# Product Change Notification

## 107487 - 00

**Change Notification #:** 107487 - 00  
**Change Title:** Intel NetStructure (R) MPCBL0001 Single Board Computer, PCN 107487-00, Product Design, Removal of Ground Isolation Washer  
**Date of Publication:** April 24, 2007

*Figure 1: Location of Isolation Screw/washer*

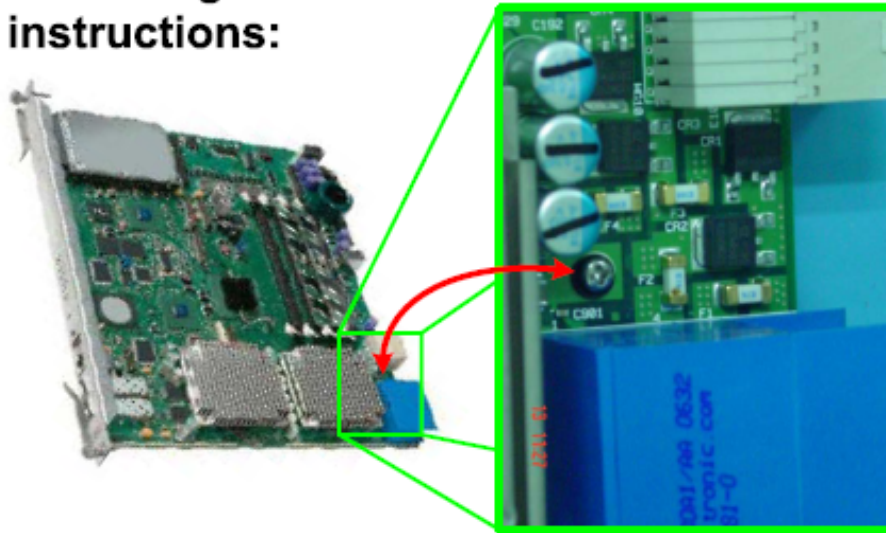
In a few cases the MPCBL0001 does not meet the IEC 60950 standard requirements of 1.3mm spacing required between TNV2 (>60VDC) and SELV (<60VDC). For Customers using installations with a >±60VDC voltage range, there is a potential for exposure to currents exceeding required limits.

As a workaround the washer which isolates chassis ground from logic ground is being removed. This change to the default grounding configuration of the board combines chassis and logic ground together. This is an acceptable PICMG grounding configuration.

1. Take steps to confirm appropriate grounding of board and service person prior to removing board from ESD bag.
2. Using a #1 Phillips head screw driver, remove and dispose of screw from board located beside the large blue power connector P10, as shown in figure 1.
3. Remove screw and washer from plastic bag and install plastic washer onto the screw.
4. Replace the screw removed in step 2 with the combined screw and washer using a #1 Phillips head torque screwdriver. Torque to 4 in-lbs.
